XJS (1993 Model Year) SECURITY SYSTEM

ADDENDUM to Fitting Instructions

LED and Valet Switch Installation

Fig. 1

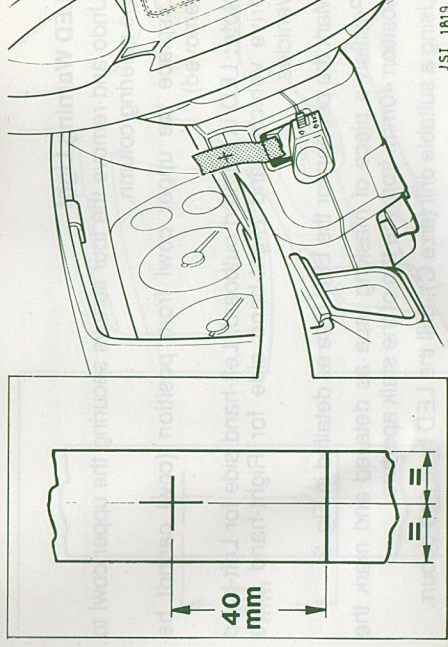
With the introduction of the driver's airbag module at 1993 MY, the locations of the LED warning light and valet switch have changed.

Mark the position for the valet switch as detailed in Fig 1.

Cut out the aperture for the switch and deburr.

Note: Switch situated adjacent to ignition lock, inboard.
